BOARD OF APPEALS

P&Z STAFF REPORT Board of Appeals Meeting, June 3, 2026

Case: **V-26-9 4630 Mount Paran Parkway**
Staff Contact: LaQuita Williams(lwilliams@sandyspringsga.gov)
Report Date: May 27, 2026

Case: **V-26-19 – 6565 Williamson Drive**
Staff Contact: LaQuita Williams (lwilliams@sandyspringsga.gov)
Report Date: May 26, 2026

Site Plan indicating proposed accessory structure in red

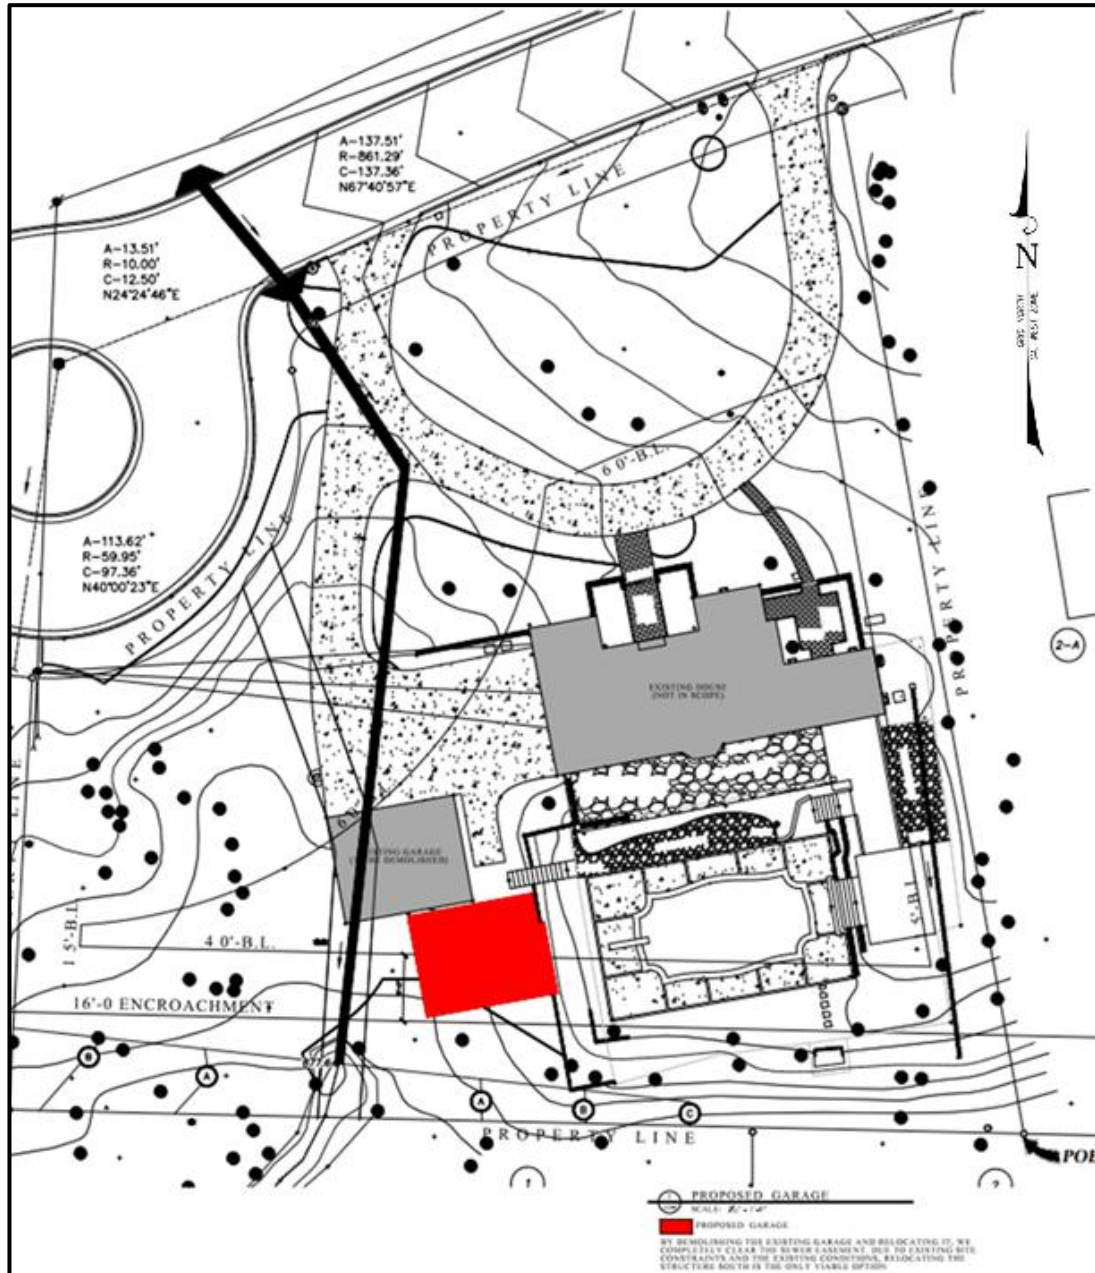
Finding: The Development Code does not permit accessory structures, over 500 square feet, to encroach into building setbacks. The applicants are proposing to exceed this limit by approximately 40%. Staff believes that approval of this variance would negate the general intent of the Development Code and Comprehensive Plan policies.

Finding: Staff finds that granting the variance would be inconsistent with the intent of the Development Code, as the proposed major accessory structure would encroach approximately 16 feet into the required 40-foot rear setback despite the availability of alternative design options.

Finding: Staff finds that the applicant has not sufficiently demonstrated that the requested variance is the minimum necessary to afford relief. The property appears capable of supporting reasonable improvements without encroaching approximately 16 feet into the required rear setback. Staff believe alternative design configurations may exist that would reduce or eliminate the extent of the requested encroachment while still allowing the garage to be relocated outside of the stormwater sewer easement.

Refer to the marked-up plan that I added in the Attachments. Please elaborate on why this location does not work. Explain how "any movement to the east would adversely affect the existing elevated pool deck, site walls and exterior stairs, as well as the parking pad." Better yet, provide a sketch for those of us who are more visual.

There appears to be an alternative where the proposed garage would be outside of the drainage easement and possibly comply with administrative variance allotment

Site Plan

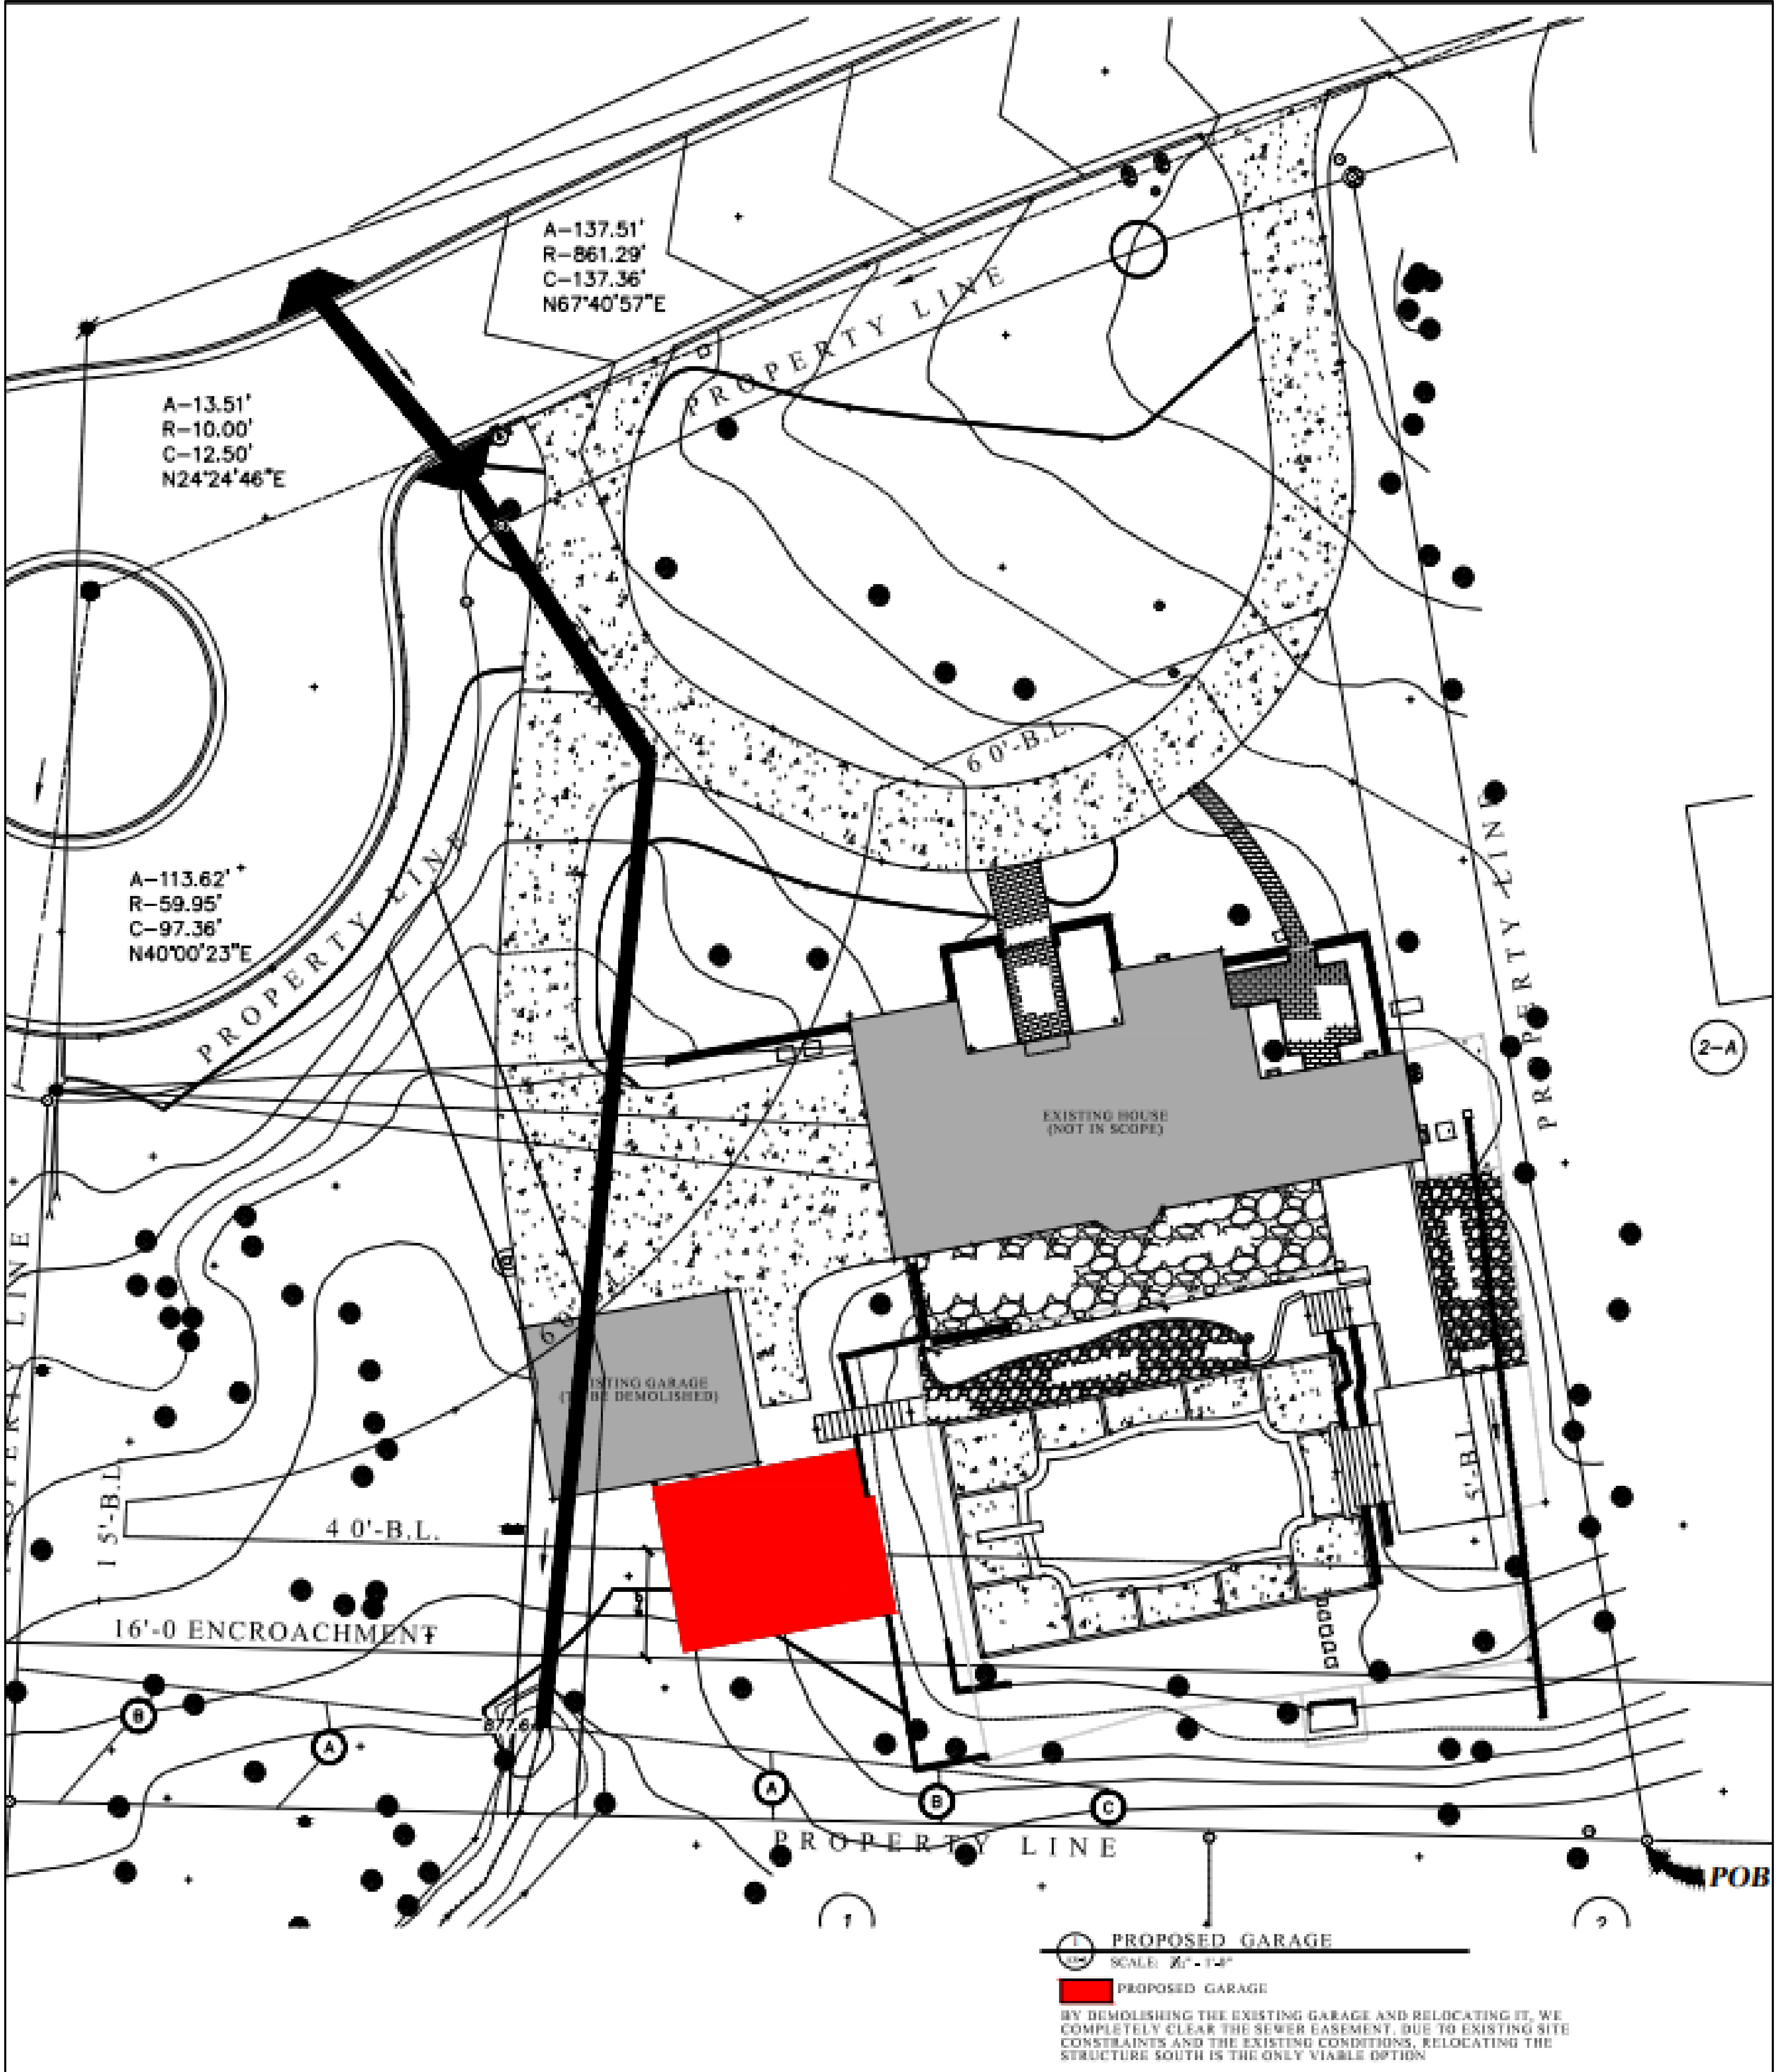
The site is developed with an existing two-story residence, contains no significant environmental constraints, and does not appear to be impacted by unusual topographic conditions that would limit reasonable development opportunities on the property. Staff finds that relocating the garage outside of the easement does not create a hardship that would justify a new encroachment approximately 16 feet into the required 40-foot rear setback.

Staff finds that the applicant has not sufficiently demonstrated that the requested variance is the minimum necessary to afford relief. The property appears capable of supporting reasonable improvements without encroaching approximately 16 feet into the required rear setback. Staff believes alternative design configurations may exist that would reduce or eliminate the extent of the requested encroachment while still allowing the garage to be relocated outside of the sewer easement.

Staff finds that the requested variance is primarily the result of the applicant's proposed site design rather than conditions unique to the property. The applicant is voluntarily removing the existing garage and constructing a new garage elsewhere on the property.

- Staff recommend **Denial** of Variance V-26-9 a request for relief from Sec. 2.2.2 and Sec.7.8.24.B.1.c to construct a detached garage that encroaches 16 feet into the 40-foot rear setback.

SITE PLAN (received April 15, 2026)

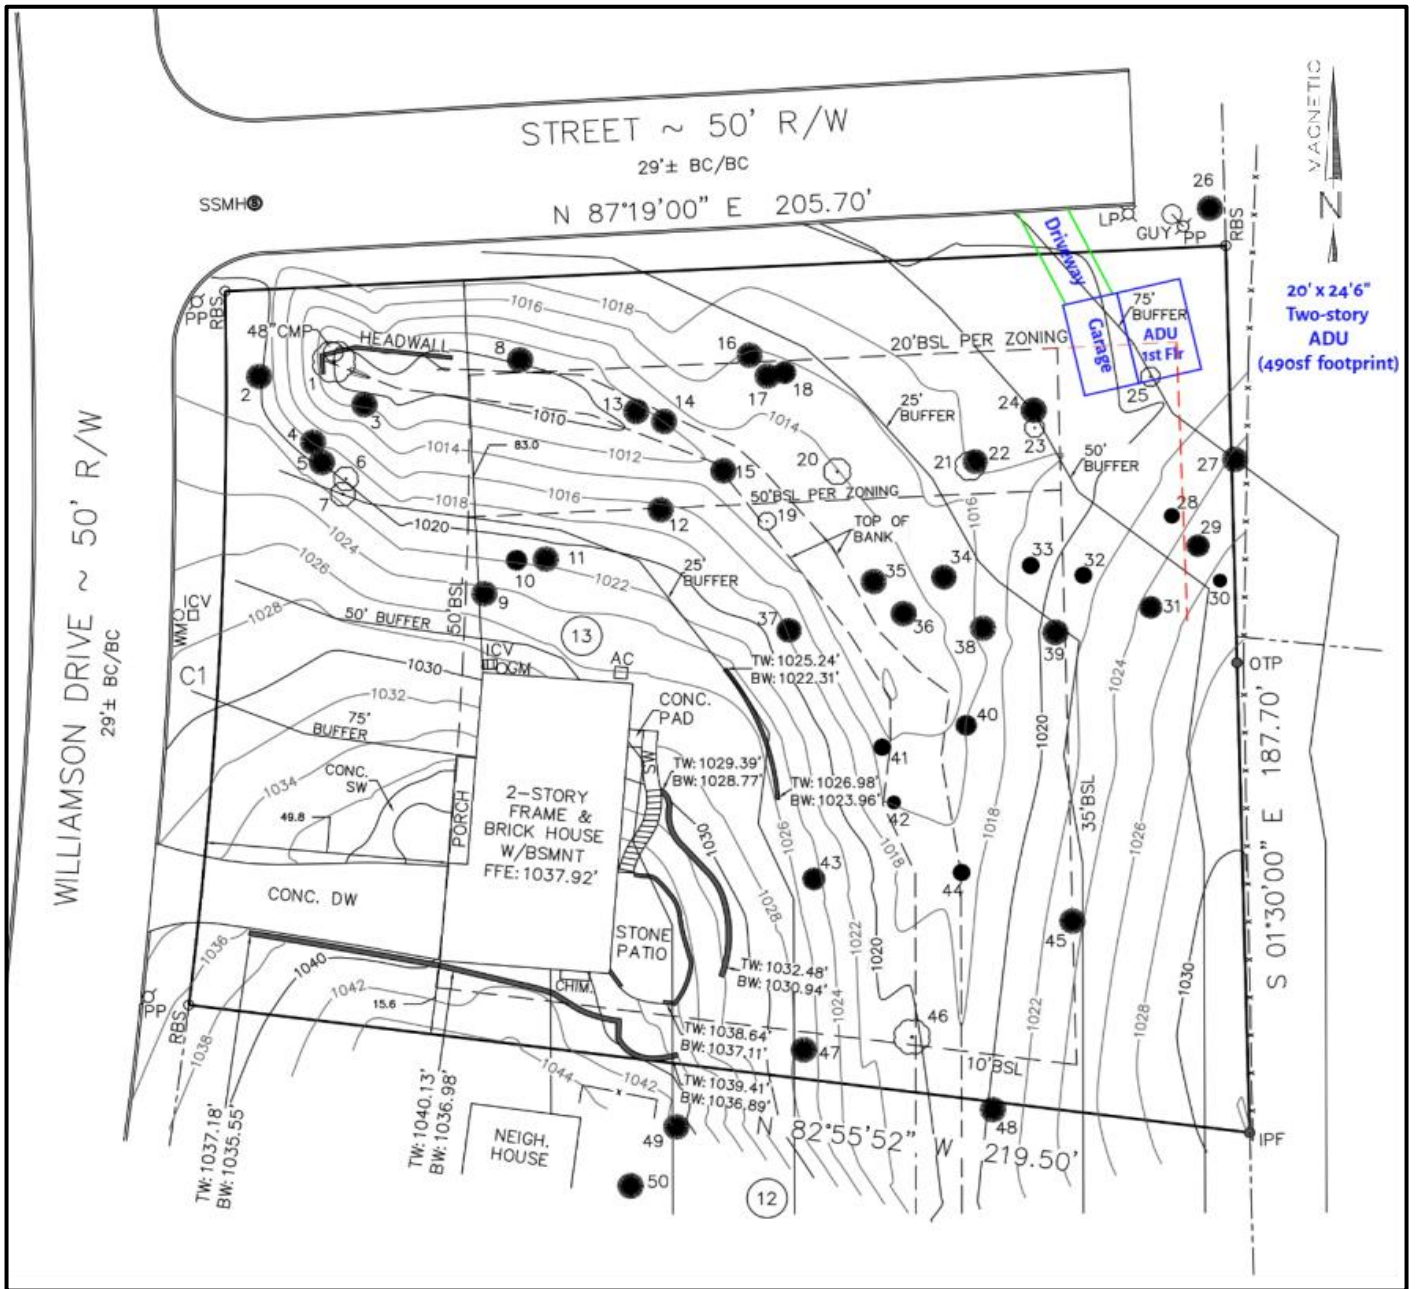
Finding: The property was platted in 1957, prior to December 12, 2005, and the existing home was constructed in 1964. The subject property is significantly constrained by stream buffers. A stream traverses the rear yard, resulting in the associated stream buffers, 25-foot state buffer, 50-undisturbed buffer, and 75-foot impervious surface setback, encompassing majority of the existing home and the entire rear yard.

Due to these physical constraints and existing site conditions, development of the property is limited without the requested variance. The applicant's request to encroach into the side, rear and impervious surface setbacks is intended to minimize disturbance and avoid further encroachment toward the stream buffer area.

Finding: The proposed variance has a limited scope and the intrusion is minimum. The applicant's proposal is as far away from the creek as practicable.

P&Z, if this were approved, would we want to have as a condition some sort of buffer planting to provide screening for the neighbors?

1. That the accessory structure does not exceed 24 feet in height and
2. That the construction be substantially similar to the provided site plan.
